PRODUCT ADVISORY

Data Sheet Specification Change for Intersil Product ISL36111*

**Refer to:
PA10105**

Subject: **Data Sheet Specification Change for Intersil Product ISL36111***

FIGURE 8. TYPICAL APPLICATION REFERENCE SCHEMATIC FOR ISL36111

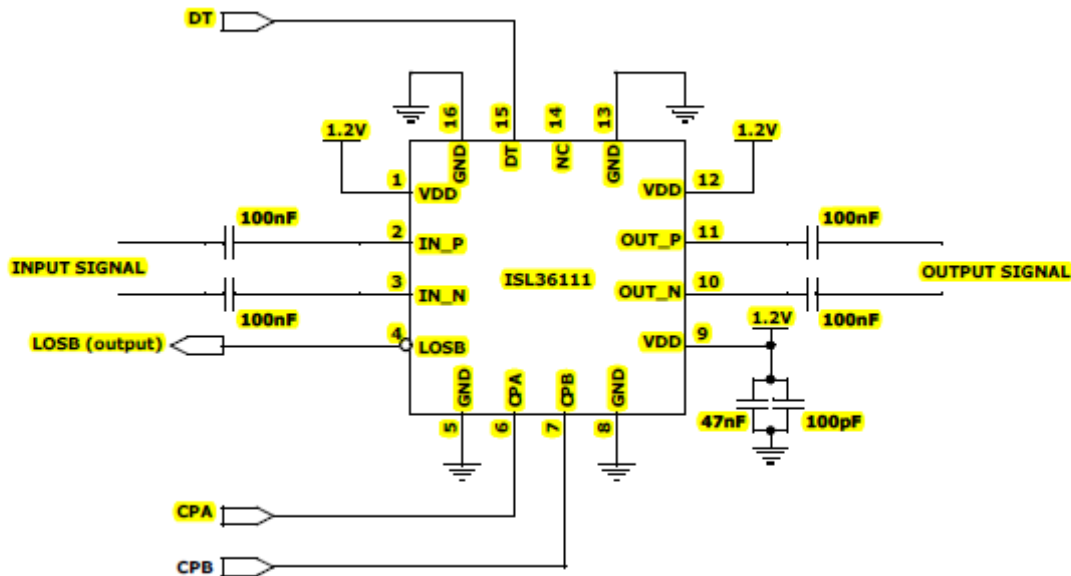
- i) The description for the VDD pin in the Pin Descriptions table was updated to recommend the use of parallel 100pF and $47nF$ decoupling capacitors to ground for each of these pins.
- ii) The description for the CP[A,B] pin in the Pin Descriptions table was updated to indicate the pins are read as a *2-digit* number to set the boost level.
- iii) Added Figure 8 - Typical Application Reference Schematic and a section titled PCB Layout Considerations.

Typical application schematic for ISL36111 is shown in Figure 8.

16. Although the filtering network is shown only for one V_{DD} pin for simplicity, all the V_{DD} pins need to be connected in this way.
